USDOT Pedestrian and Bicycle Safety Assessment Gary, Indiana April 16, 2015

USDOT Pedestrian and Bicycle Safety Assessment

Indiana MPO Conference
October 14, 2015

Photos of Lake St, US 20 to 3rd

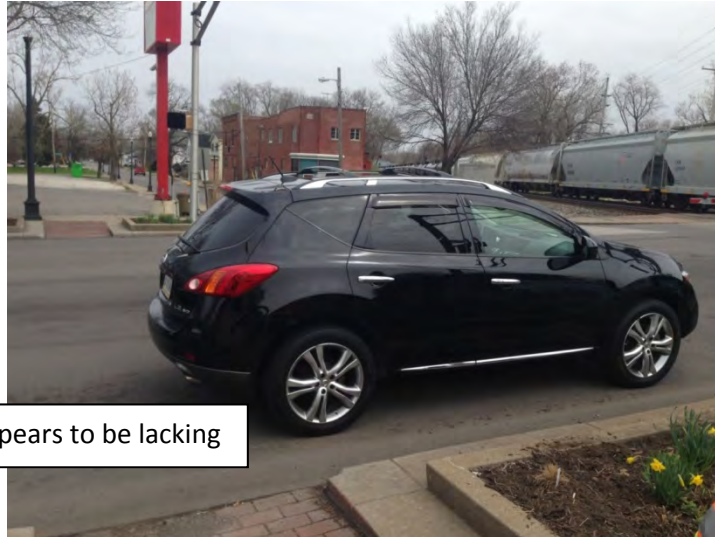
Signal coordination improvements needed with trains and pedestrians

No transit stop signs

Sidewalks are discontinuous at railroads crossing along Lake St

No crosswalk markings or railroad warning signs for pedestrians or vehicles

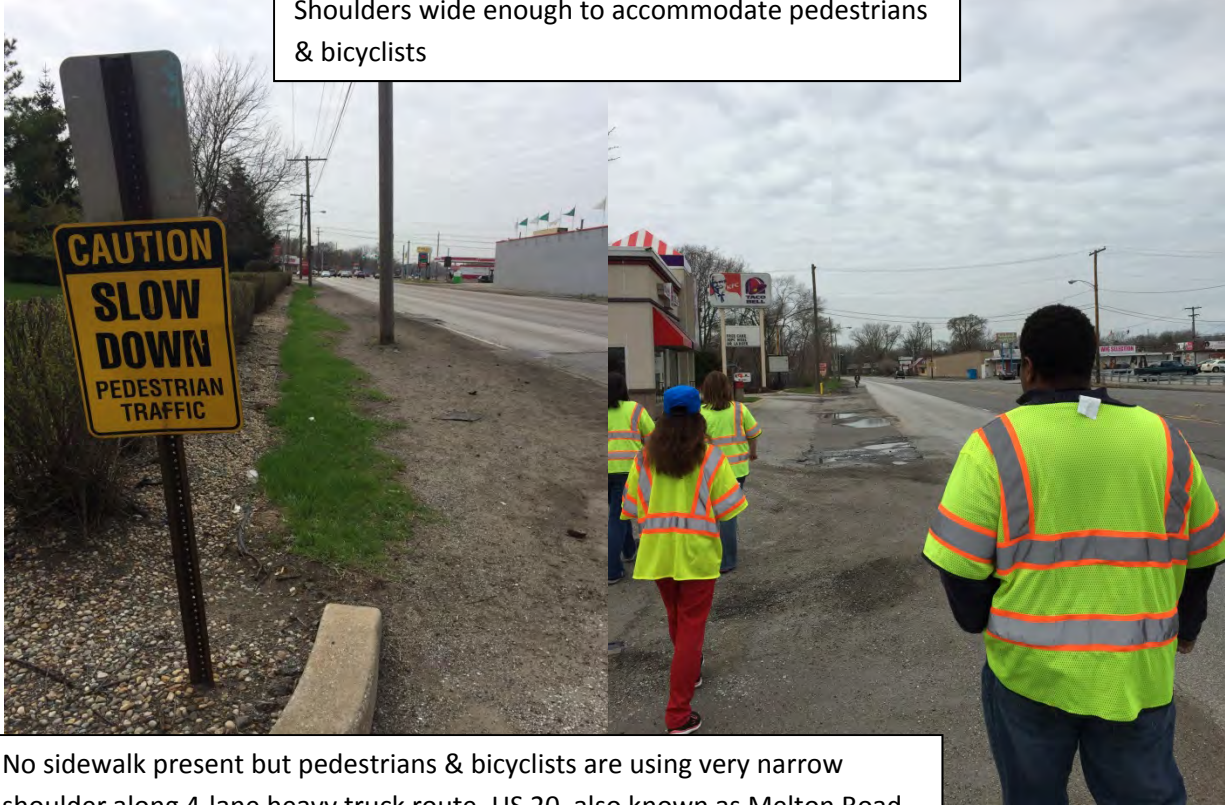
Shoulders wide enough to accommodate pedestrians & bicyclists

No sidewalk present but pedestrians & bicyclists are using very narrow shoulder along 4-lane heavy truck route, US 20, also known as Melton Road

Photos of Group 4 Bike 35th Avenue

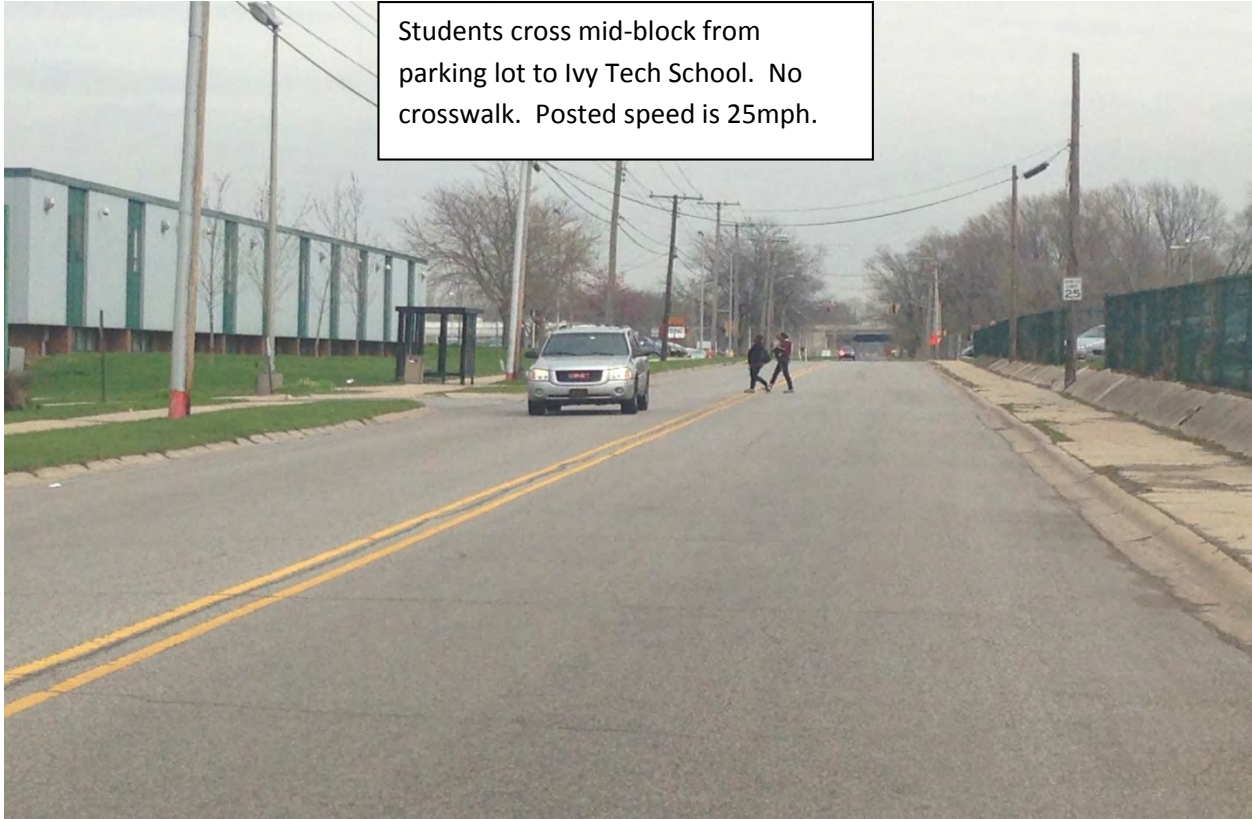
35th Avenue is a wide 2-lane road that could incorporate bike lanes and reduce 40 mph speed limit

Grates not designed for bicyclists

Sign's height is an obstacle. Other warning signs down.

Sign in the ramp at a bus stop presents an obstacle

Bus stop sign has been on ground for a while
